MANATEE COUNTY

SUBJECT: Request for Quotation #13-1398-OV
Fiber Optic Installation, City of Palmetto, MCAT Palmetto Bus Station

ADDENDUM #2

Drawing 2

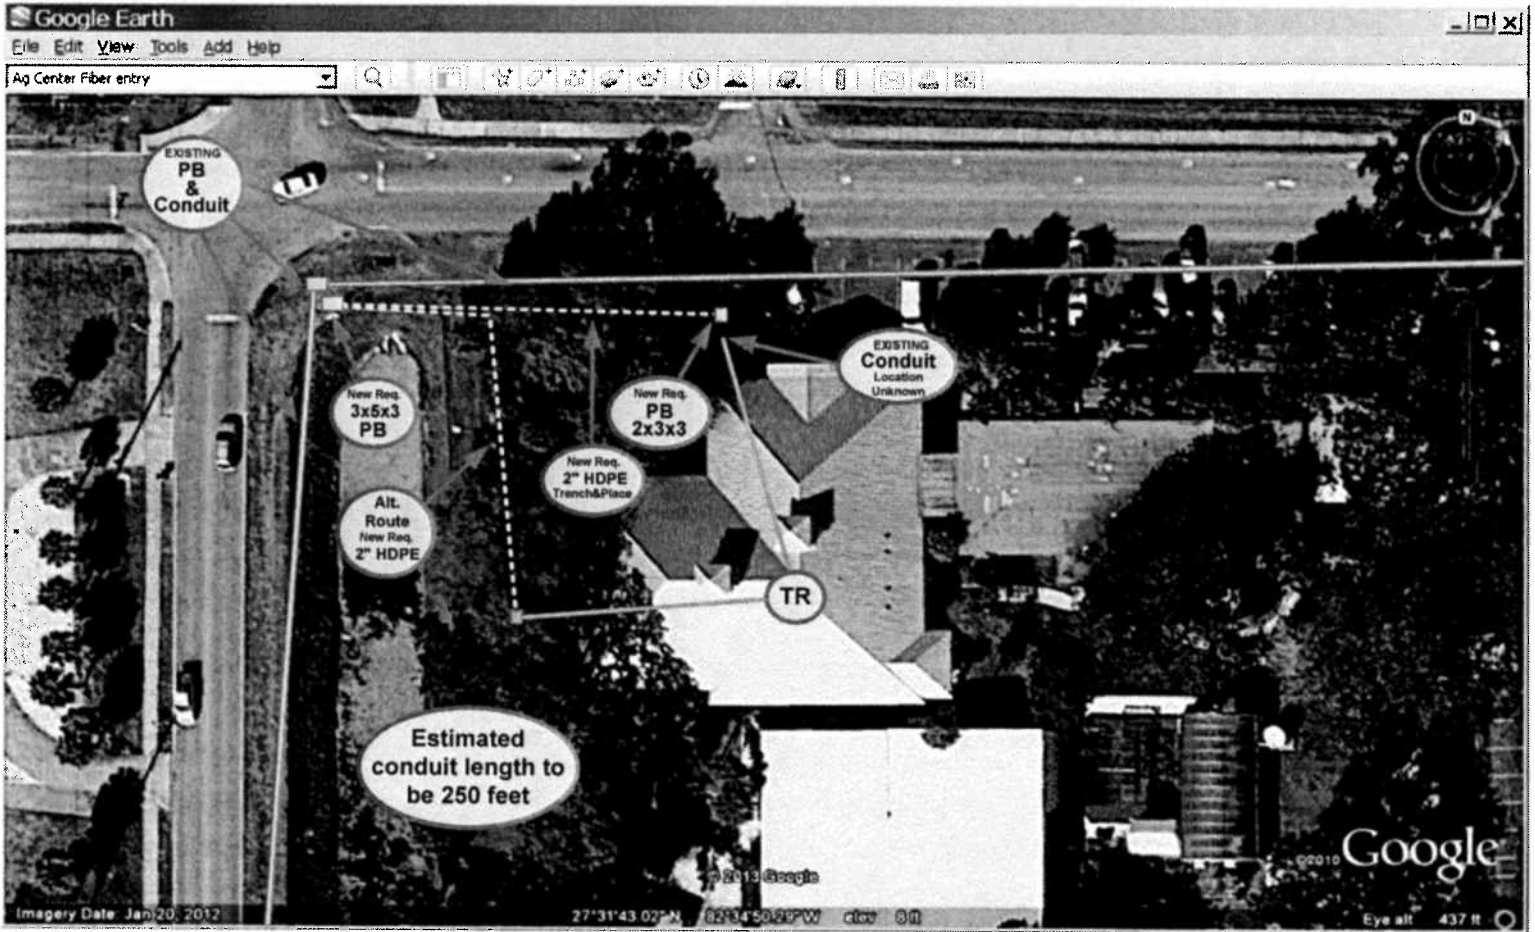
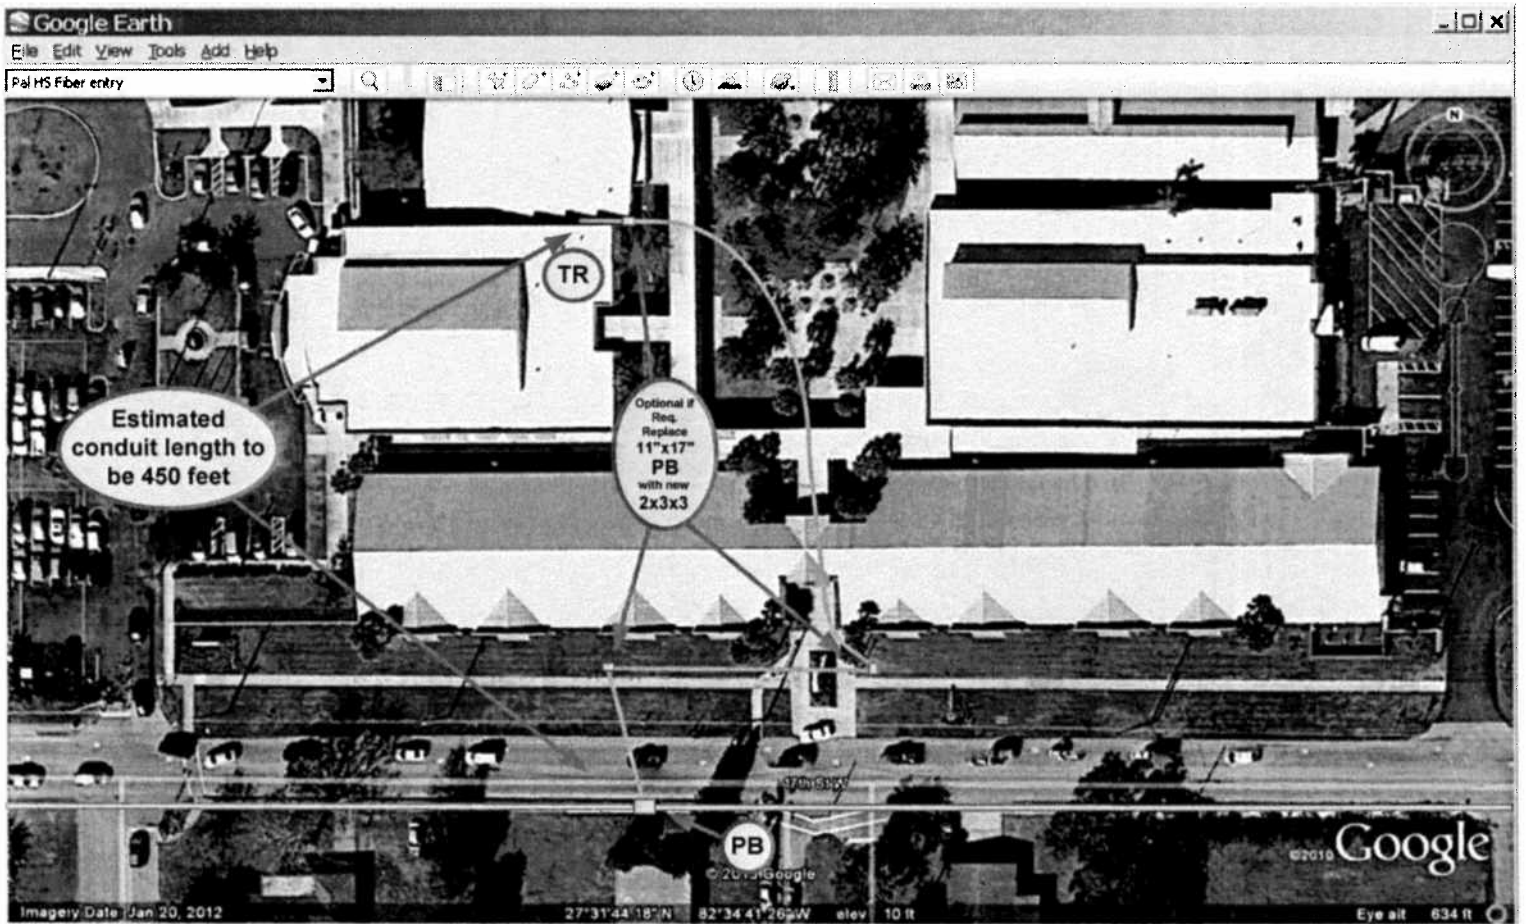
**SITE 1: Agriculture and Natural Resources Center – 1303 17th Street West, Palmetto, FL 34221
(See revised drawing 2, attached)**

Provide and install a new 3x5x3 vault next to the existing City of Palmetto vault at the corner of 17th Street West and 14th Avenue West, Palmetto, FL. Place (1) 2" HDPE conduit between new vault and existing vault. Engineer, furnish and install (1) 2" HDPE conduit along the indicated route to the Pedestal location as shown on the drawing. Pull (1) 12-count Draka fiber optic cable and a traceable mule tape from the fiber vault at the corner of 17th Street West and 14th Avenue West along with (1) 12-count Draka cable that was pulled through the existing 1-1/4" conduit with the 144-county Draka fiber through new 2" HDPE and terminate within the TR of the Agriculture and Natural Resources Center. The County will define which strands are to be used for the termination into the 144-count. The County will also define which 6 of the 12-count from the Palmetto High School will be terminated. Upon completion of fiber placement, cable is to be spliced, terminated, placed in proper interface unit, labeled, tested and documented as per specifications provided with the Request for Qutoation.

NOTE: Existing 4" conduit that Brighthouse is currently using to enter TR may be used for new fiber access, however, the exact exit point at the Pedestal location outside is not known at this time. Marked on updated drawing is location of alternate route into Ag Center's TR that can be used. Regardless of the entry location used, a 2x3x3 pull box will need to be provided and installed as a transition point.

Question 24: Can the contractor propose alternate means for entry and access to the TR at Site 1 AG & Natural Resources?

Answer 24: As part of this Addendum #2, an alternate path has been identified and the drawings have been revised to show the alternate path.

Drawing 3

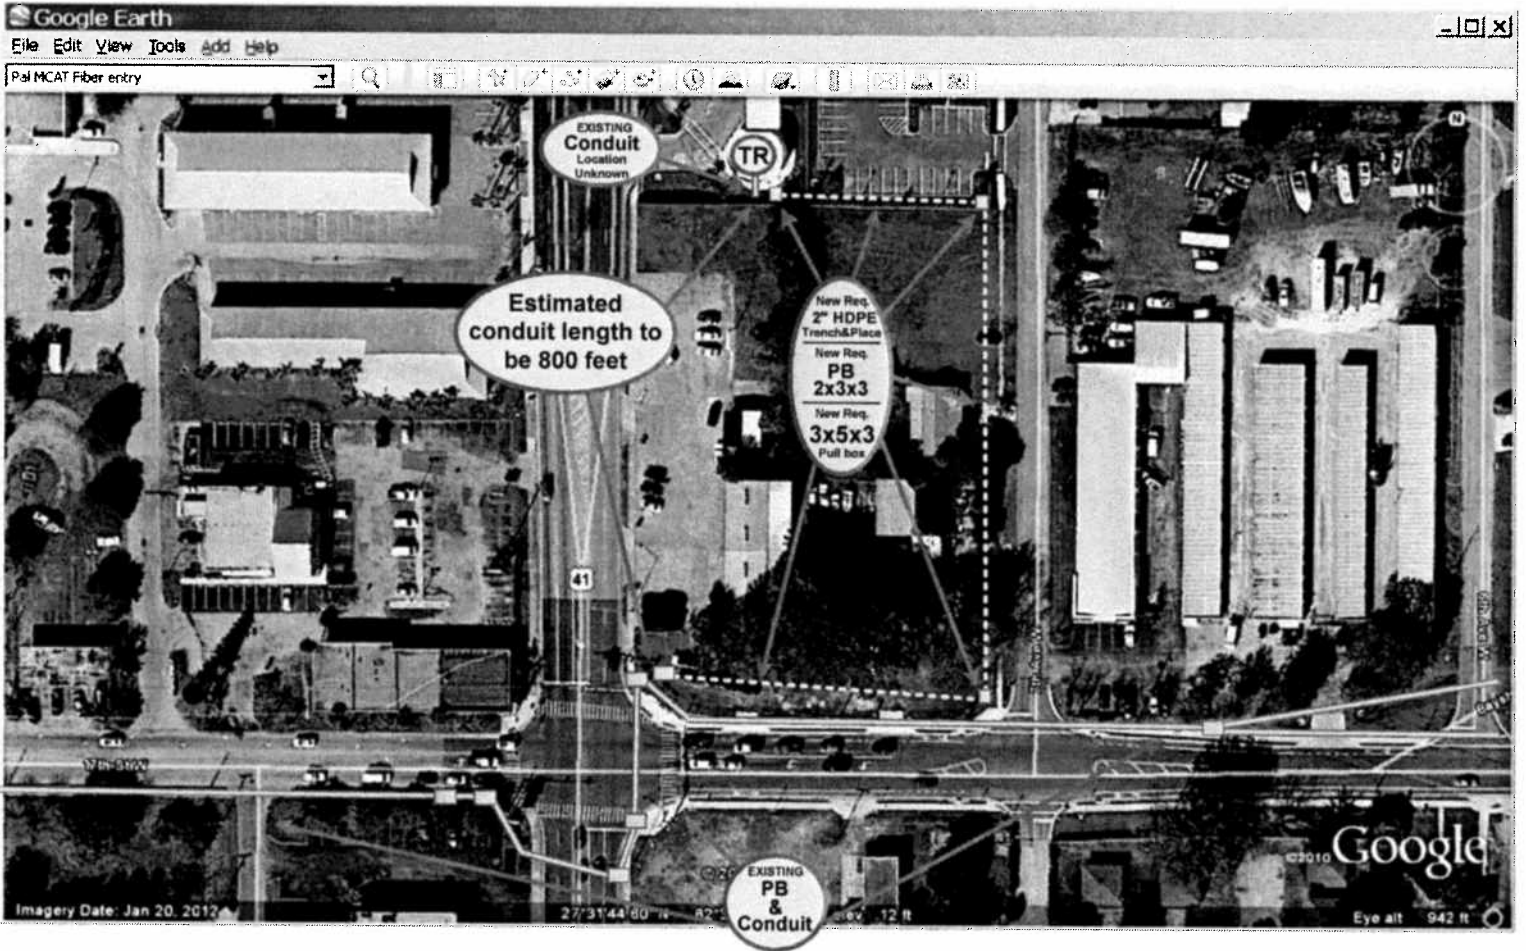
SITE 2: Palmetto High School – 1200 17th Street West, Palmetto, FL 34221 (See revised drawing 3, attached)

From the existing vault in front of the Palmetto High School, pull in the 12-count Draka fiber optic cable that was pulled in alongside the 144-count Draka Fiber optic cable along with a traceable mule tape through the existing 1-1/4" School Board HDPE conduit, terminating 6 of the 12-count within the TR of the Palmetto High School as indicated on the drawing. The County will define which strands are to be used for the termination into the 144-count. Upon completion of fiber placement, cable is to be spliced, terminated placed in proper interface unit, labeled, tested and documents as per the specifications provided with the Request for Quotation.

NOTE: This fiber will require installation in an already occupied conduit. **As an option, provide pricing to replace existing 11" x 17" pull boxes with the new 2x3x2 pull boxes as indicated on Drawing 3.**

SITE 3: MCAT Palmetto Bus Station – 1802 8th Avenue West, Palmetto, FL 34221 (See revised drawing 4)

From the newly placed vault at the corner of 17th Street West and 8th Avenue West, Palmetto, FL, please engineer, furnish and install (1) 2" HDPE conduit along the indicated route to location as shown on the drawing, placing a new **3x5x3 and 2x3x3** pull boxes at all designated locations. Place 12-count Draka fiber optic cable and a traceable mule tape from the vault at the corner of 17th Street West and 8th Avenue West through new 2" HDPE and terminate within the TR of the Palmetto MCAT Bus Station. The County will define which strands are to be used for the termination into the 144-count. Upon completion of fiber placement, cable is to be spliced, terminated, placed in proper interface unit, labeled, tested and documented as per the specifications provided with the Request for Quotation.

NOTE: Transition point from last newly placed pull box to existing underground conduit is not know at this time, however, the location of the last PB should be at that point once located. Existing conduit which Brighthouse is using may also be used for new fiber access. Approximate location of the conduit is shown on the drawing.

SCALE
 HORIZONTAL: _____
 VERTICAL: _____
 SHEET _____ OF _____
 SHEET #: Locate Detail

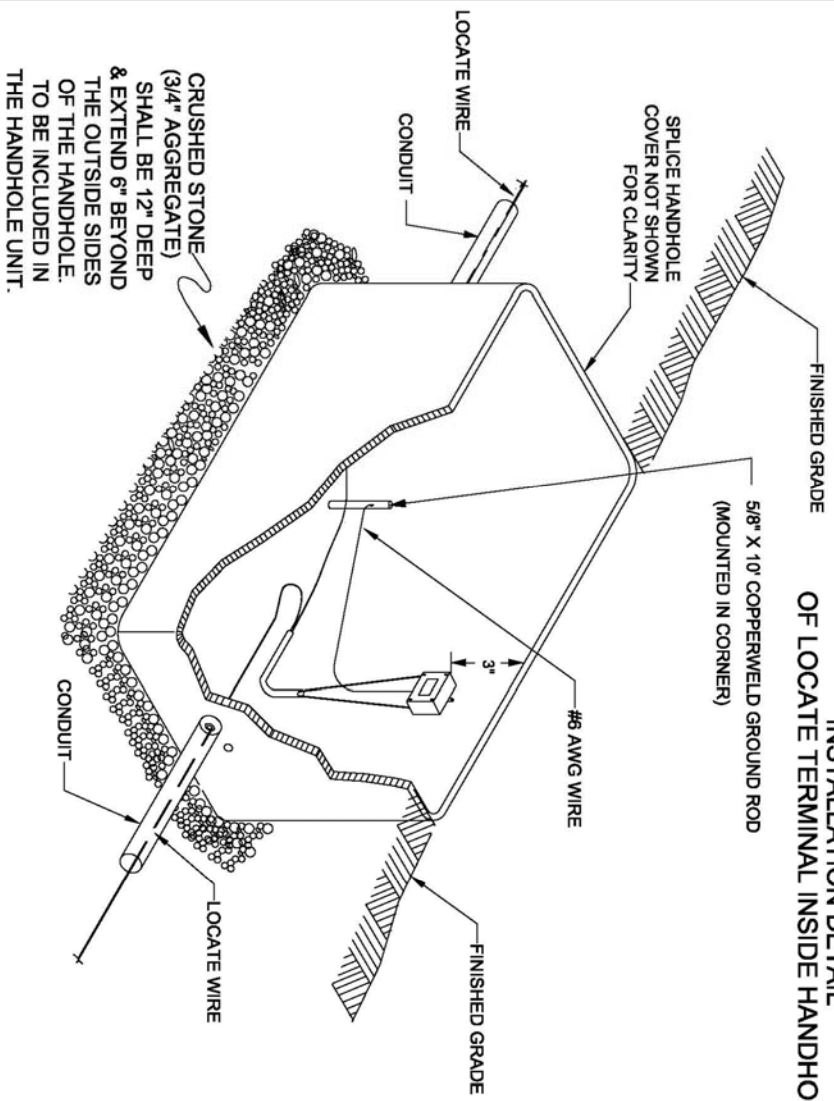
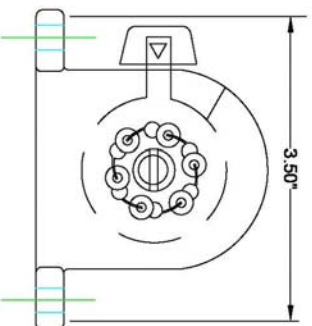
Question 10: Regarding Attachment “G”, Locate Wire Detail, the notes at the bottom of the sheet are not legible. Please provide legible copy.

Question 11: Regarding Attachment “G”, Locate Wire Detail, the Electric Motion terminal block shown appears to conflict with the locate wire splicing described by 2.2.9 on page 37. Please clarify locate system.

Question 12: Regarding Attachment “G”, Locate Wire Detail, please clarify if the “handhole” shown is a requirement at the locate wire splices OR is the same as the pull boxes / splice boxes for the fiber optic cabling?

Answer 10: Revised Locate Wire Detail will be provided as a PDF with this Addendum #2.

Answer 11: Remove Electric Motion terminal block and surge suppression (4.1.2) from required items.

Answer 12: The splice location for the locate wires will be the fiber pull box at the existing locations. New pull boxes will require the installation of a flush mounted test station external to the pull box.
